S.Pietro di Feletto 06/05/2005

SUBJECT : Changes on transmitter ERONE type SETW295AM2

Old version	New version
Layout

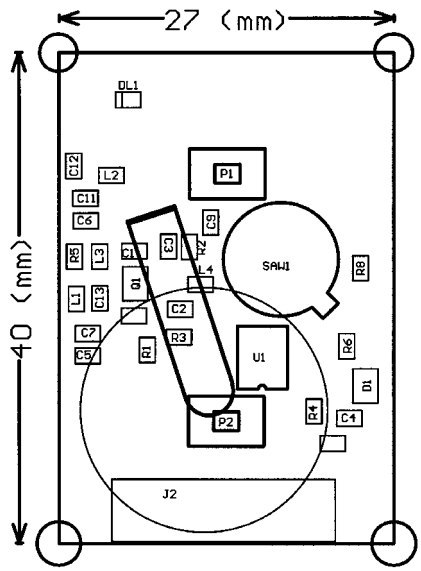
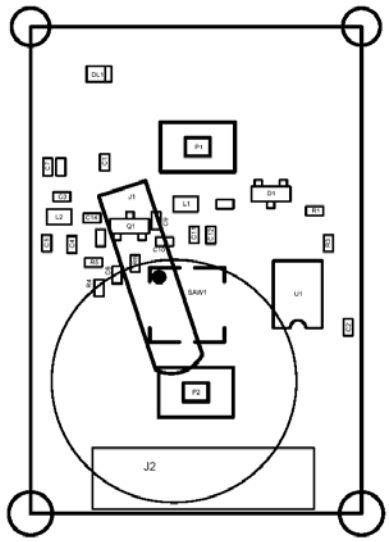
1) the microprocessor has been changed from the type Microchip PIC 12C508 to the type Microchip PIC 12F629;
2) as conseguence of this, has been changed the PCB of the transmitter, and the layout;
3) the battery contact has been changed;
4) The Saw Resonator has been changed as packaging from PTH to SMT
